INDESIT company

Model type:
WITE87EU

Commercial code:
F034269

n1040345: Replacement of drum lock button TL EVOII.

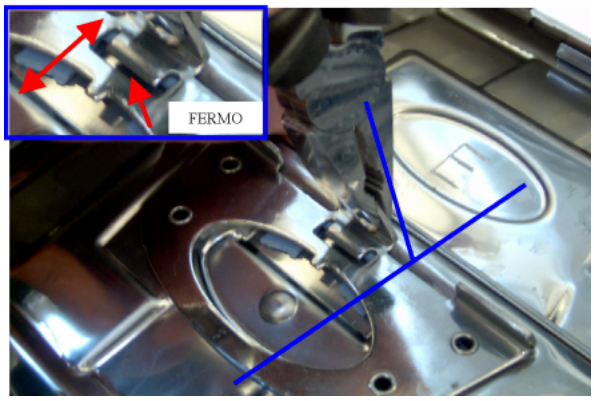
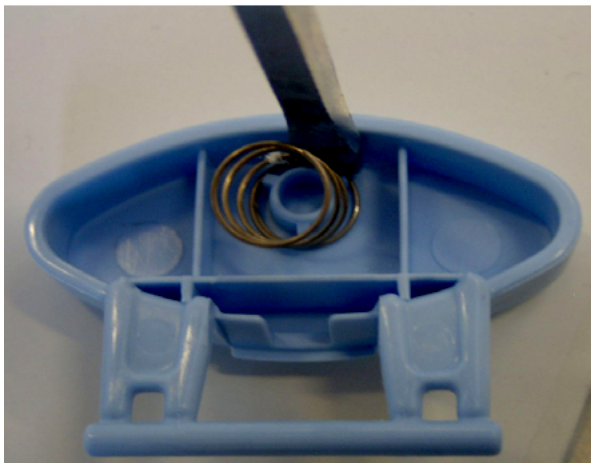
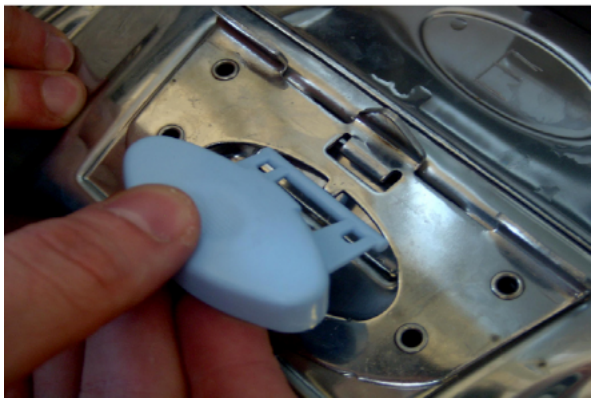
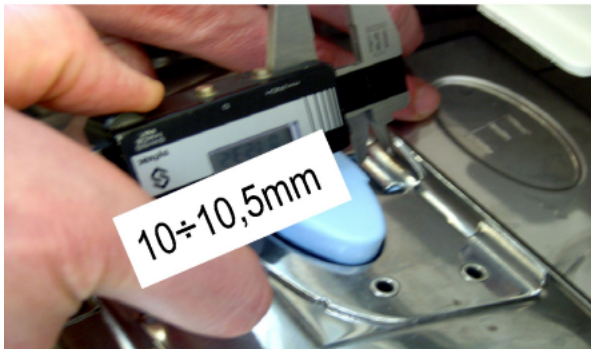
Tools and material needed: pliers, screwdriver, gauge, spring P/N Sat 114989, button P/N Sat 114990.

1) turn the central tip of the catch in the direction shown (FIG.1);

2) bring the tip to a vertical position and ensure that the broken button is disengaged from the catch restraint and can be removed (FIG.2);

3) remove the remaining part of the button with the aid of a screwdriver, taking care not to scratch the doors (FIG.3);

4) pre-assemble spring to button (FIG.4);

5) insert button between catch and door (FIG.5);

6) bring the button into position and arrange the spring in its location in the door (FIG.6);

7) turn the central tip of the catch in the direction shown to return it to its starting position (FIG.7);

8) check the distance between button and catch (FIG.8);

9) check correct operation of the button when opening and closing the doors (slight inclination errors of the catch can result in

faulty closing of the doors) (FIG.9).

n1040382: Drain pump with bayonet-style filter - top Loading Brembate

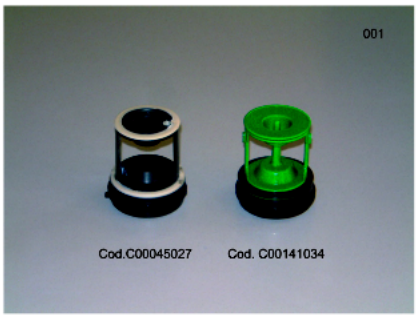
From serial no. 51021.0001 a new drain pump with bayonet-style filter has been installed on all top loading washing machines manufactured in Brembate.

New parts:
C00141862 - Drain pump
C00141034 - Pump filter kit

Premodification parts:
C00111409 - Drain pump
C00045027 - Pump filter kit

The new parts can be used instead of premodification ones.

N1040404FIG1

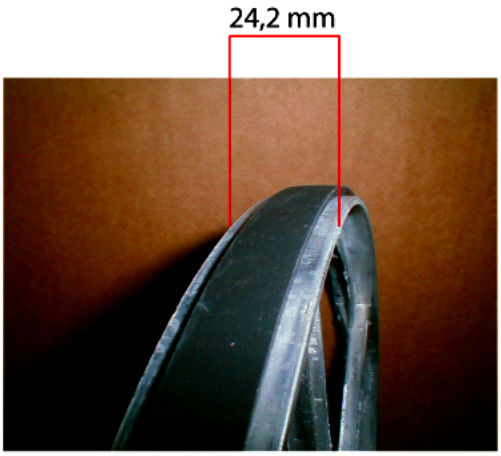
From serial no. 51202.0001 the pulley track has been widened from 21.2mm to 24.2mm (see picture N1040404FIG1).

new pulley
C00142832 - D280 24.2 mm track

Premodification pulley
C00083912 - D280 21.2 mm track

The new pulley can also be used on premodification versions of the models referred to in this release.
